Regional Interest Development Approval - Response to Requirement Notice (RPI21/001 BMA - Saraji East)

We refer to the regional interest development approval (RIDA) application for the construction of a new overhead 66 kilovolt (kV) powerline for the Saraji East Mining Lease Project (SEMLP) (the Project) over Lot 101 on SP310393 within the strategic cropping area (SCA). The RIDA application was made on 8 February 2021 under the *Regional Planning Interests Act 2014* (RPI Act).

Figure 1 - 77-SCL

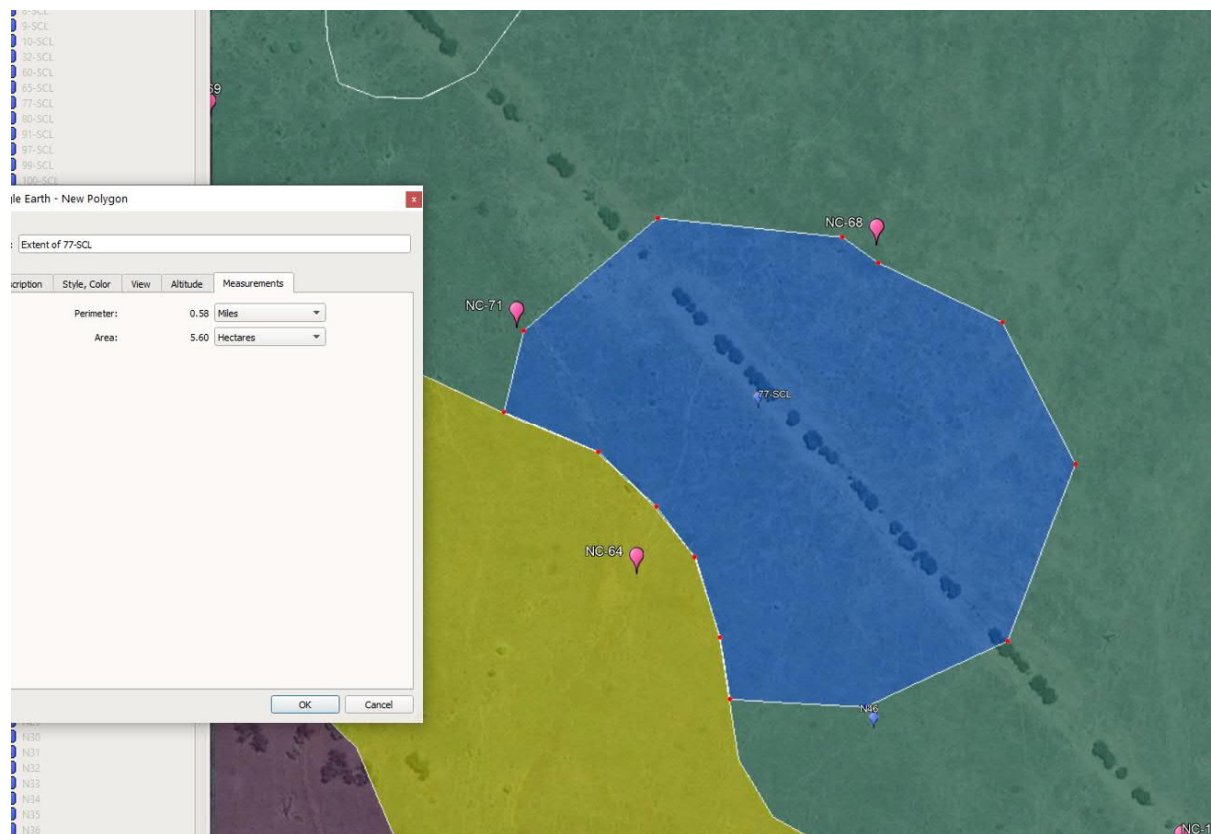
- (a) Confirm the extent of compliant SCL and non-compliant SCL within Map Unit 6, focusing the additional analytical sites within the area depicted in Figure 1. All Map Units still need to conform with the required site density of Table 3 of the RPI Act Guideline 08/14.
- (b) If additional areas of SCL (more than 10 ha) and Map Units are identified within Map Unit 6, provide additional analytical sites to confirm the SCL compliance of the remaining areas of the Map Unit.

Map Unit 6 was re-assessed based on the area and surrounding areas. Refer to the Revised SCL Assessment Report (Attachment B), Section 3.6, page 32.

Map Unit 18 containing site 77-scl as well as five additional detailed sites were assessed during the fieldwork, with two of those sites being analysed. Sites were observed to be a black dermosol and

grouped together. The extent of the compliant SCL within Map Unit 18, which includes Site 77-SCL was mapped at 5.6 ha, which is less than 10 ha based on surrounding check, detailed and non-SCL compliant analytical sites. Refer to the Revised SCL Assessment Report (Attachment B), Section 3.18, page 83. Please refer to Figure 1 for reference.
